Access Compliance Report

Public Rights-of-Way

(Curb Ramps)

Intersection ID: 23333	Main Street: SHARON_RD_WEST	Cross Street: REGENT_PARK_LN	Location: SW
ADA ID: 53D07076129A	Ramp Type: PerpDiag	Initial Pass/Fail: Fail	Overall Compliance: No
Severity Score: 50			
Codes/Mitigation Info/Possible Solution		Field Measurements/Component Compliance

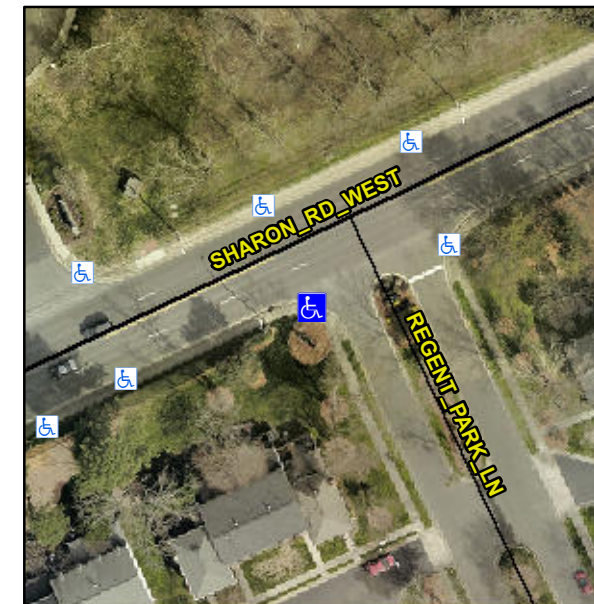
Not Found, R304.2.2, R304.5.3

Compliance	Description	Data	Compliance	Description	Data
N/A	Ramp Length (in)	61.0	No	Ramp Slope (%)	12.3
Yes	Ramp Width (in)	48.0	No	Ramp XSlope (%)	14.9
N/A	Flare Type LT	N/A	N/A	Flare Type RT	N/A
N/A	Flare Slope LT (%)	N/A	N/A	Flare Slope RT (%)	N/A
N/A	Flare Traversable LT?	N/A	N/A	Flare Traversable RT?	N/A
N/A	Landing Length (in)	N/A	N/A	DWS Provided?	N/A
N/A	Landing Width (in)	N/A	N/A	DWS Contrast?	N/A
N/A	Landing Slope (%)	N/A	N/A	DWS Length (in)	N/A
N/A	Landing X Slope (%)	N/A	N/A	DWS Full Width?	N/A
N/A	Landing Curb? (Y/N)	N/A	N/A	DWS Offset (in)	N/A
N/A	Shared Landing?	N/A			
N/A	Gutter Ponding?	N/A	N/A	Gutter Slope (%)	N/A
N/A	Gutter Lip Ht (in)	N/A	N/A	Gutter X Slope (%)	N/A
N/A	Painted X Walk1?	No	N/A	Painted X Walk2?	No
	X Walk 1 Direction	To E		X Walk 2 Direction	To N
N/A	X Walk 1 Width (in)	N/A	N/A	X Walk 2 Width (in)	N/A
	X Walk 1 Slope (%)	0.3		X Walk 2 Slope (%)	11.7
	X Walk 1 X Slope (%)	11.1		X Walk 2 X Slope (%)	0.6

Remove & Replace Curb Ramp With Two New Directional Ramps or Equivalent.
